Transport Assessment Addendum 2

Cabbagefield Row, opposite 123-133 Swanmore Road, Leigh Park

The purpose of this Addendum is to provide the additional information requested by HCC, following submission of Addendum 1 in September 2022.

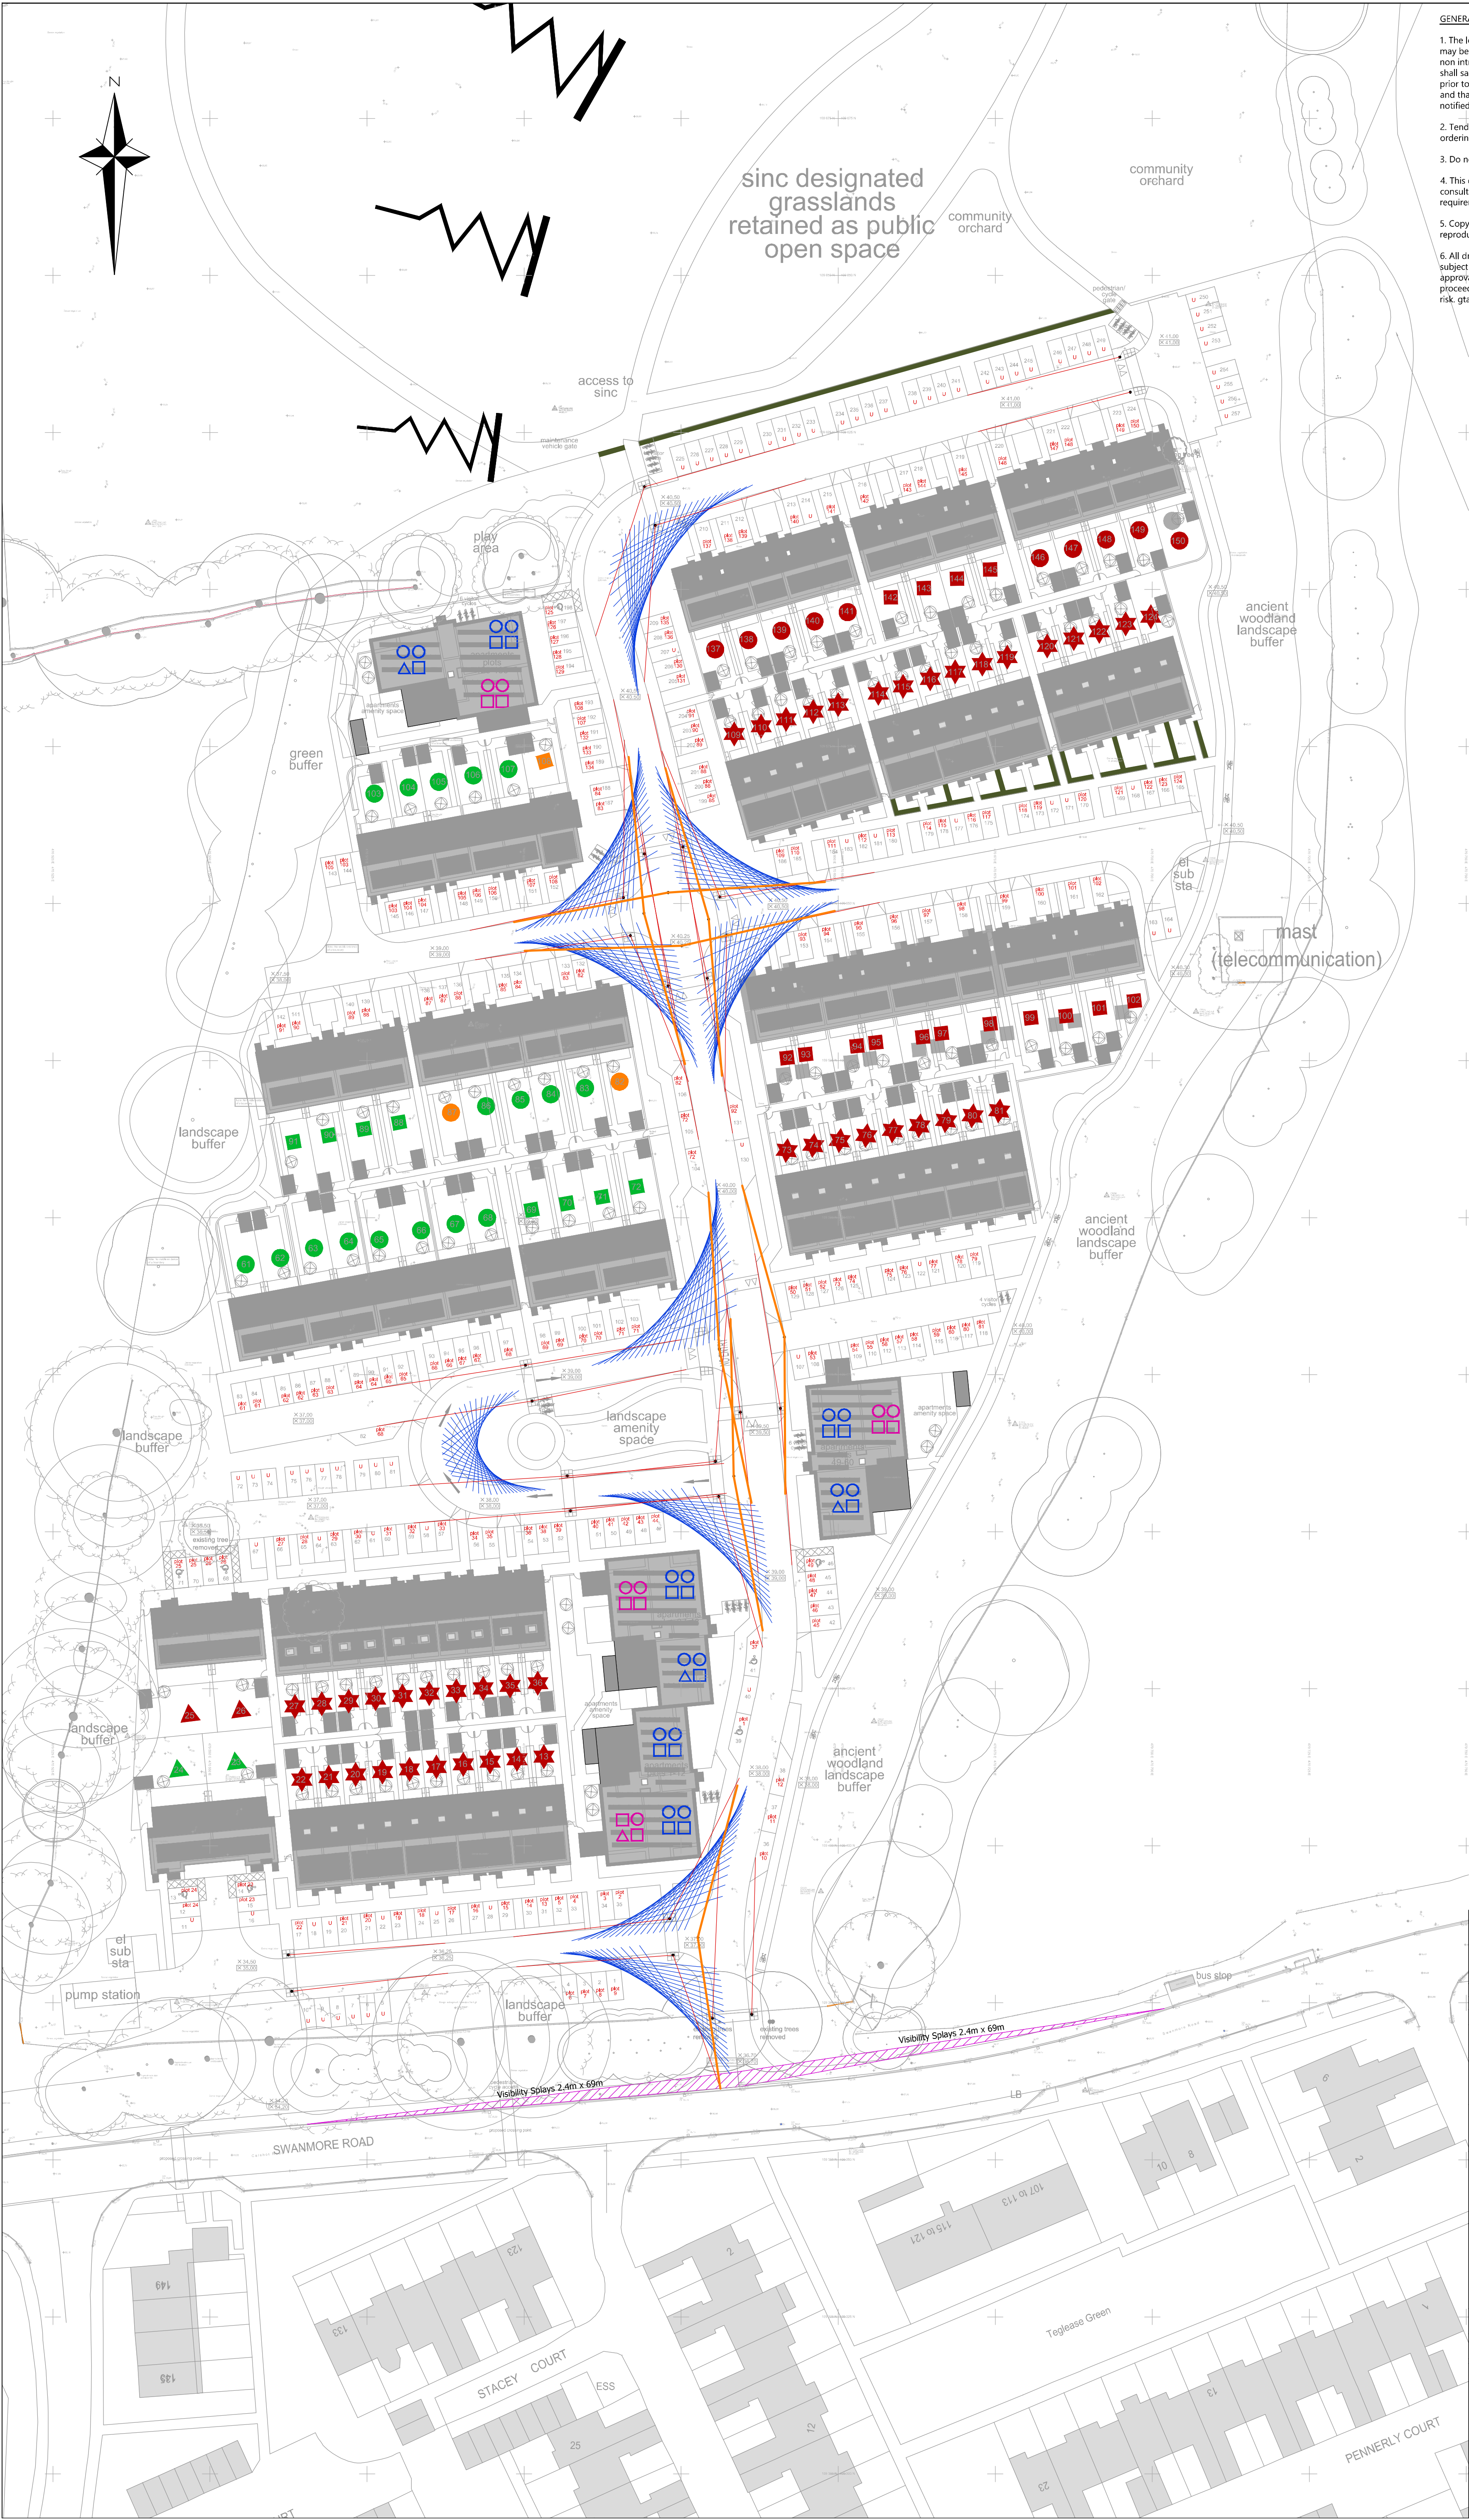
21. The full extent of forward visibility splays and pedestrian visibility splays running through landscaped areas should be offered for adoption as the current proposals are unacceptable

22. Pedestrian visibility splays should be provided for the crossing point north of the site access and at the site access

Response: Parking revised to remove from visibility splays and all splays shown within adoptable land. The reasoning in point 9 for not allowing highways to dominate layouts should be considered. All junctions have compliant visibility at give way points and vehicle speeds would be slower around road bends. The landscaped areas don't need to be offered for adoption and a condition can be applied to ensure visibility is maintained.

Response: Splays now shown.

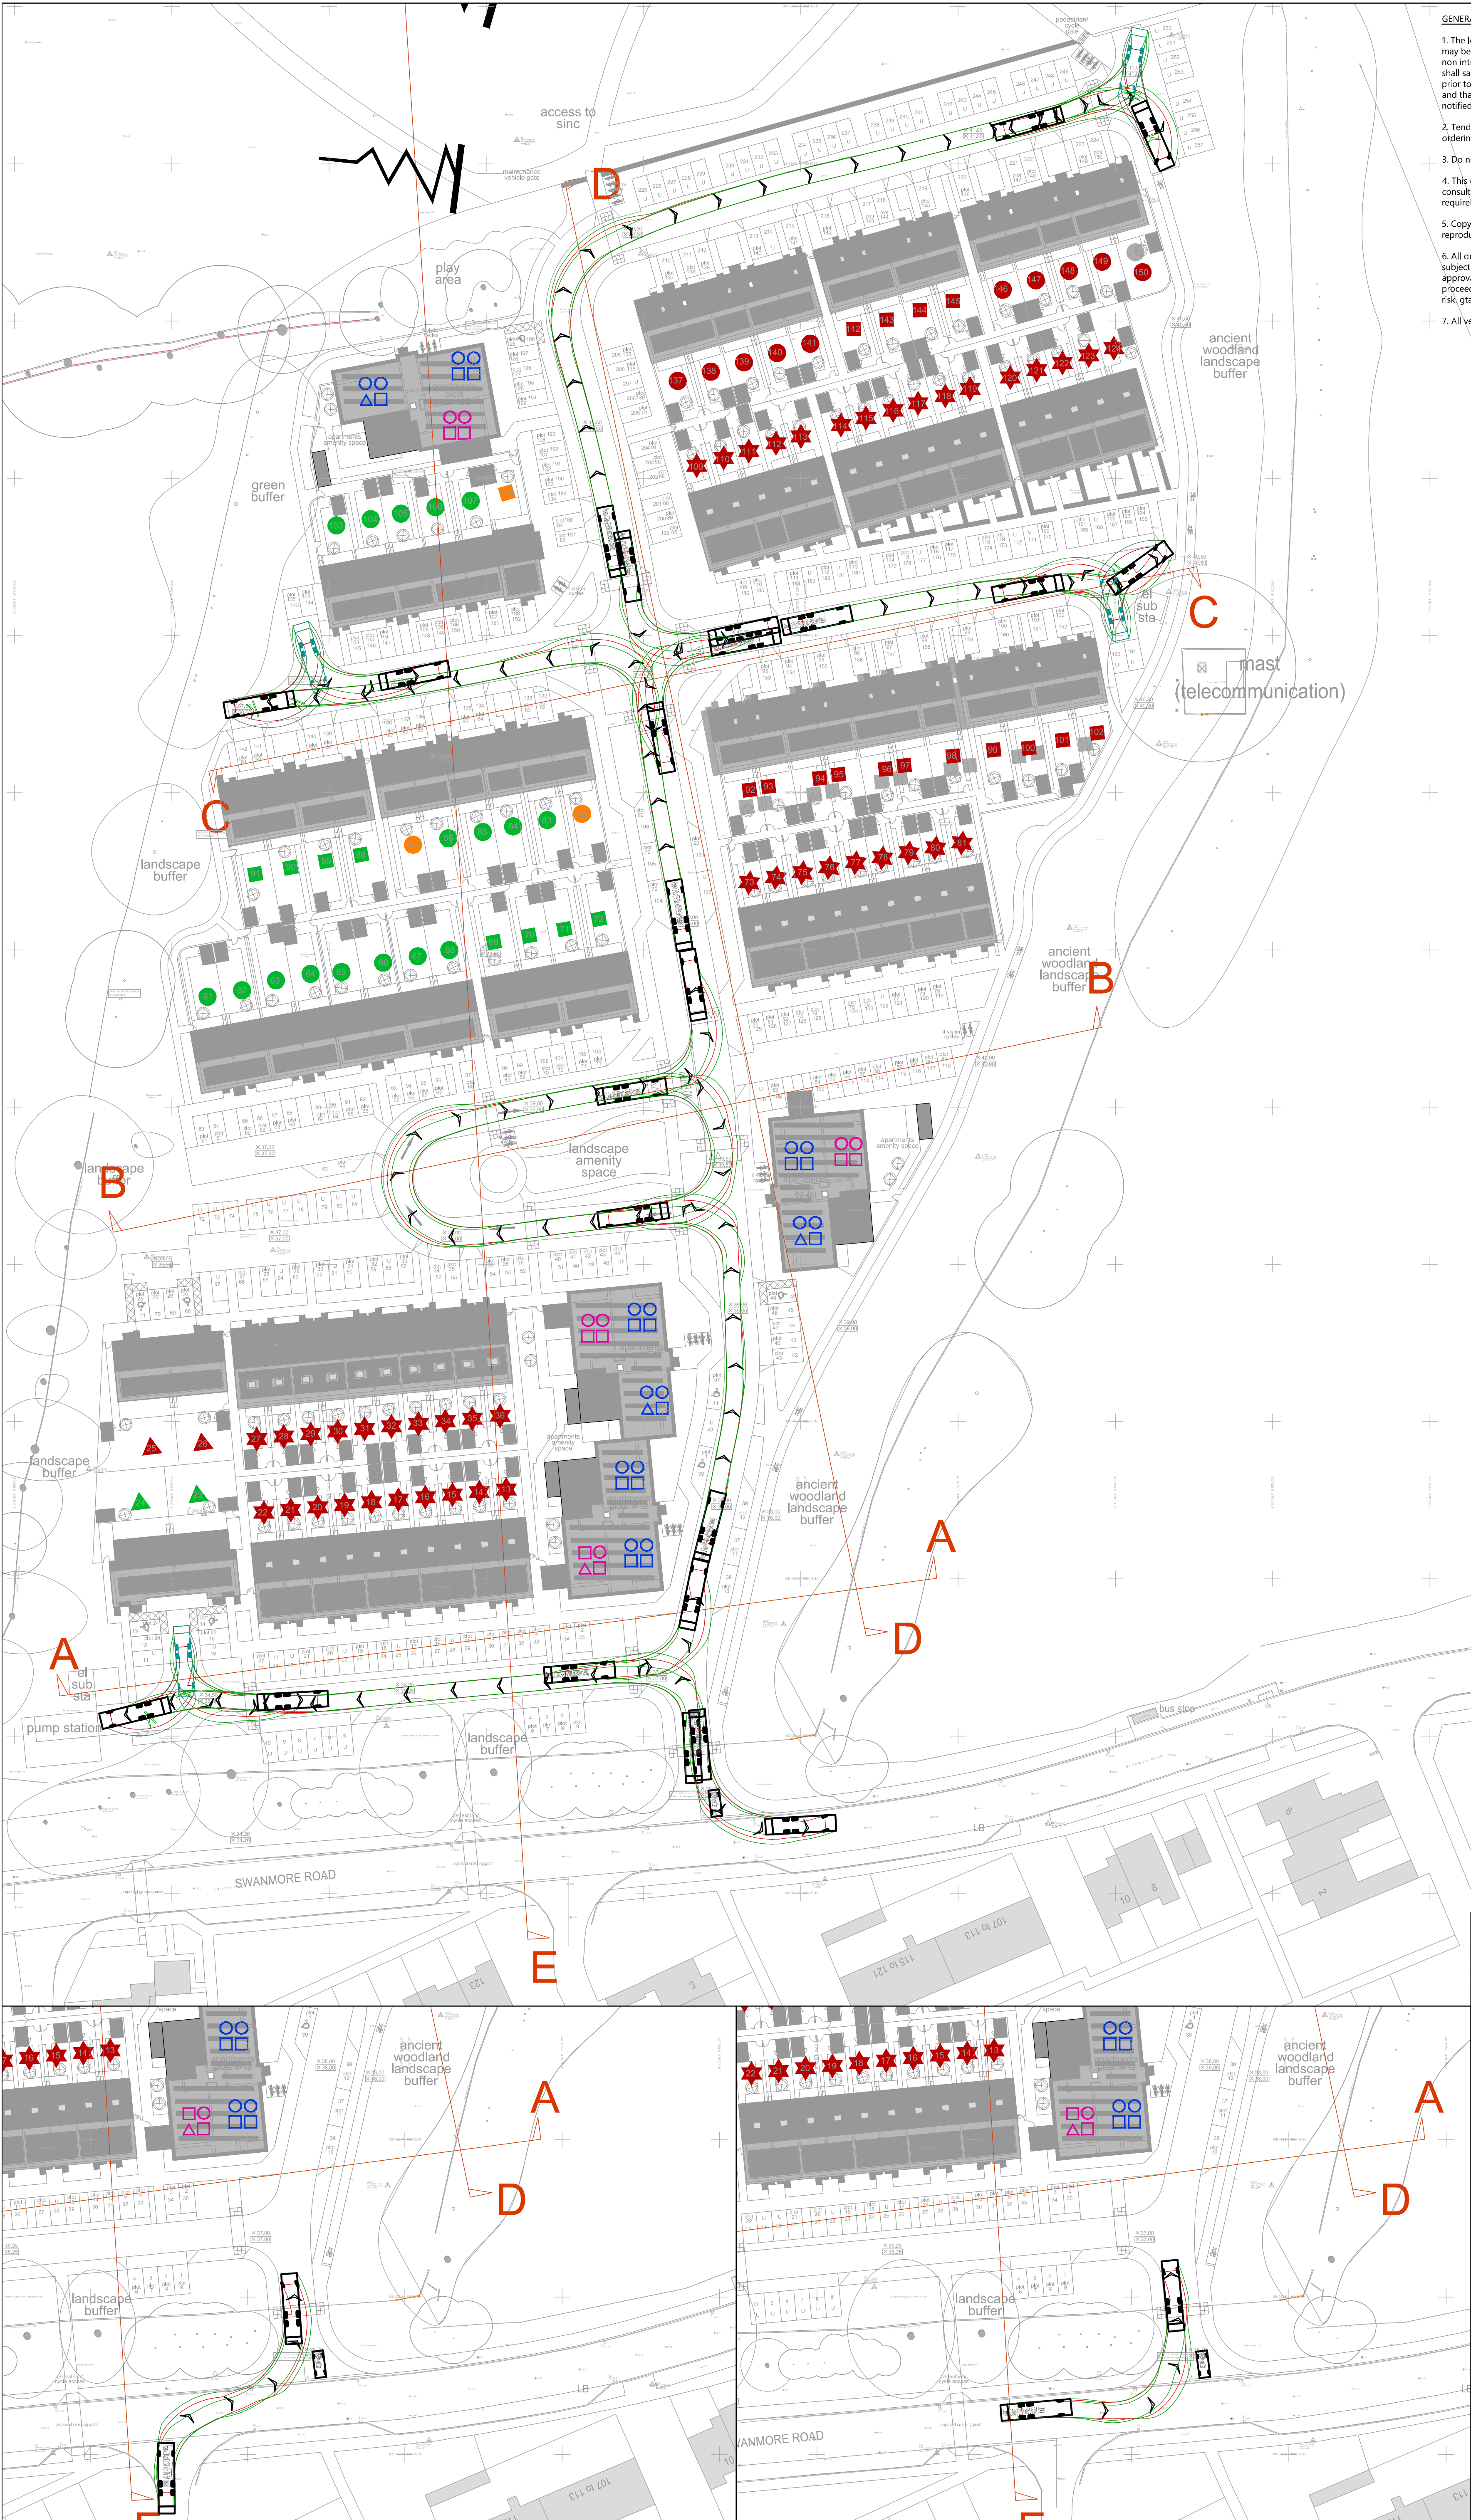
7. *Tracking speeds should be provided at a minimum of 10mph and not 4kph for both the refuse and fire tender*
Response: Adjusted to 10mph as requested. Refuse vehicles tend to service dwellings at very slow speeds to empty bins.

9. *Tracking should be provided for a refuse past a car throughout the whole development;*

13. *Tracking at the site access for a refuse [vehicle] past a car seems to conflict with the car waiting at the stop line which is likely to be exacerbated further if tracked at the correct speed and should be revised*

Response: The scheme has been designed to the principles of HCCs Companion Document for Manual for Streets. In relation to whether the layout takes priority over the streets and car parking, so that the highways do not dominate, the guidance states, 'The rigid application of highway engineering standards for roads, junction separation distances and turning circles can create an environment which is unpleasant and difficult to use, especially for pedestrians'. The preference for a refuse vehicle to pass a car through the whole layout will result in wider roads, especially near junctions and bends which is not consistent with Hampshire or Havant adopted policy.

Response: The tracking speed makes little difference. In practice it is reasonable to assume that motorists will slow down to avoid a conflict with other vehicles, especially when turning. The access is designed to HCC standards as stated in point 9.
